**ADDENDUM NO. 3**

DATE: February 10, 2020  
PROJECT: ITB 20253  
BETHUNE POINT WRF-PHASE I PROCESS UPGRADES  
OPENING DATE: ~~February 17, 2020~~ February 27, 2020

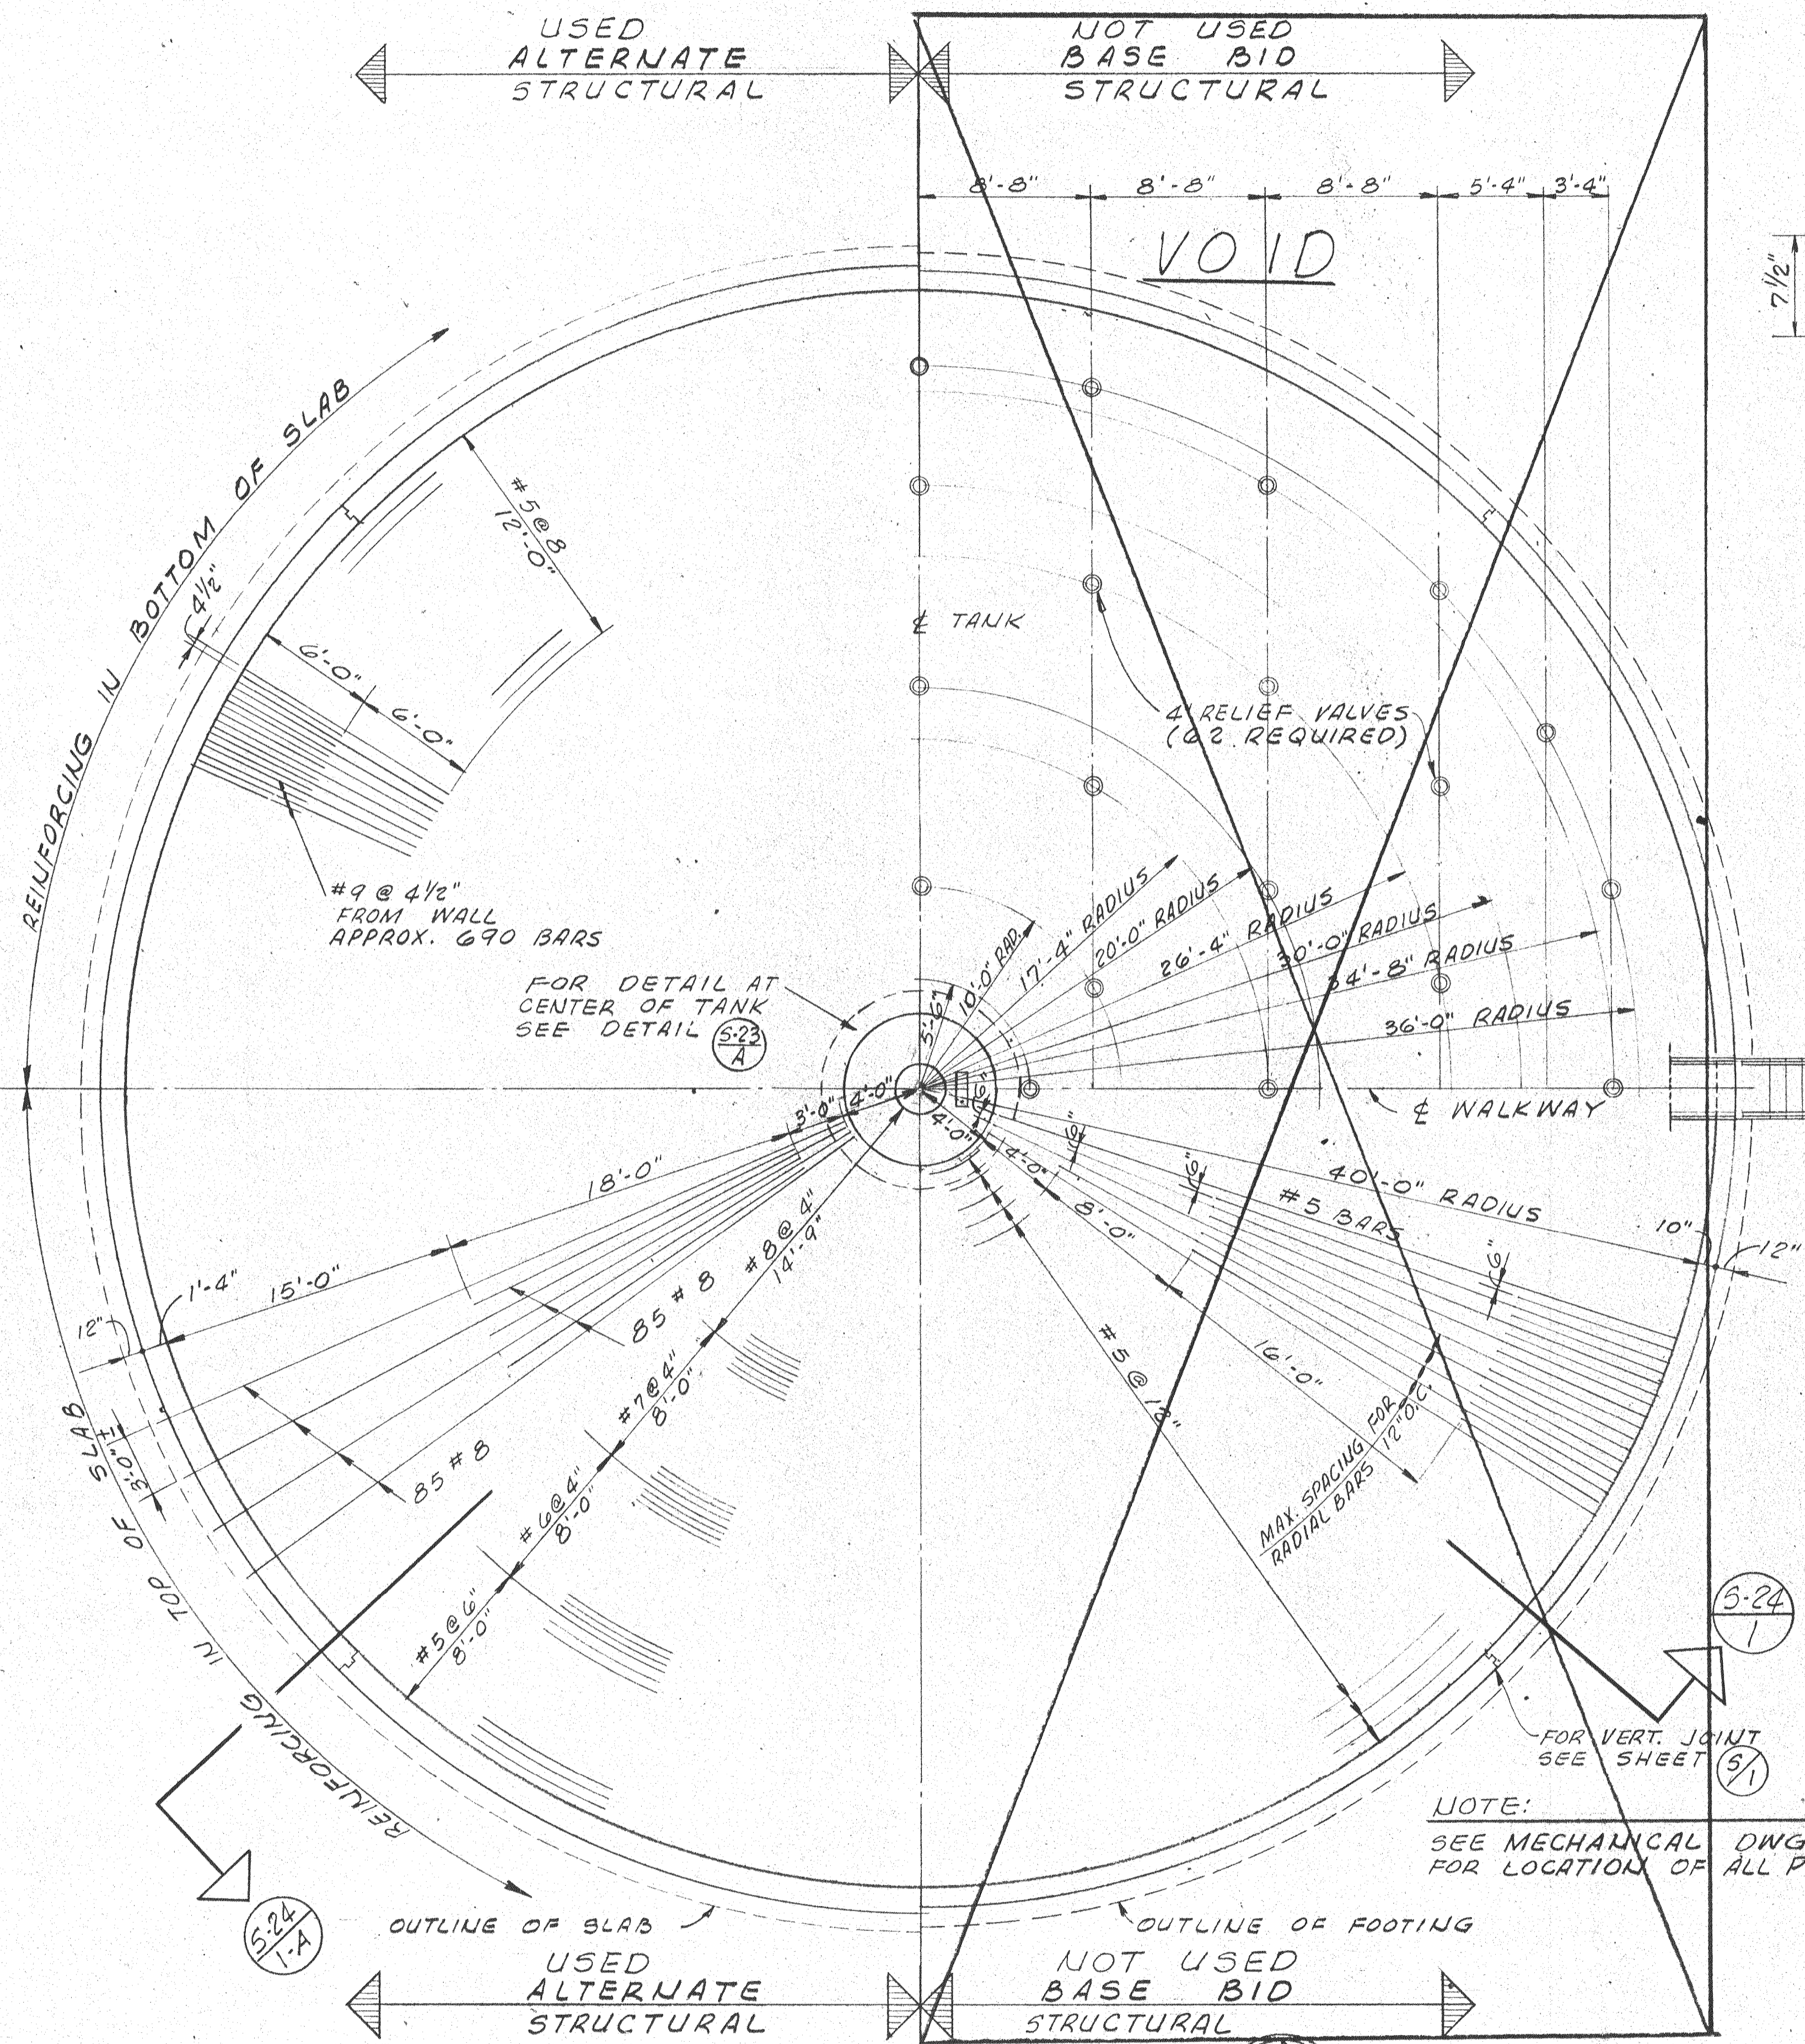
- Clarifier No. 1 – The clarifier was installed in 1965/1966. The tank was initially bid to include 4” relief valves throughout the cone, however based on the as-built drawing (included herein), it appears that the tank was installed without the relief valves. The as-built drawings further indicate that the tank is subject to buoyant forces and therefore required the installing contractor to dewater to an elevation below -1.58’ (datum unknown).

- Clarifier No. 4 – The clarifier was installed in the early to mid-1990’s. The drawings (included herein) show that the clarifier was installed with an underdrain system. The City located the underdrain manhole and visually verified it to be full of water. However the City did not do any investigation to confirm if the underdrain system is functional or not.

- Clarifier No. 1 – A bid item has been added to the bid form for groundwater dewatering of Clarifier No. 1. **The Contractor will be required to maintain the groundwater at or below the elevation of the footer as shown on the drawings for the entire time the tank is empty.**

- Clarifier No. 2 – A bid item has been added to the bid form for groundwater dewatering of Clarifier No. 2. **The Contractor will be required to maintain the groundwater at or below the elevation of the footer as shown on the drawings for the entire time the tank is empty.**

- Clarifier No. 4 – A bid item has been added to the bid form for the installation of groundwater piezometers at Clarifier No. 4. **The Contractor will be required to verify the underdrain system is functional and able to maintain a groundwater elevation at the elevation of the underdrain system as shown for the entire time the tank is empty.**
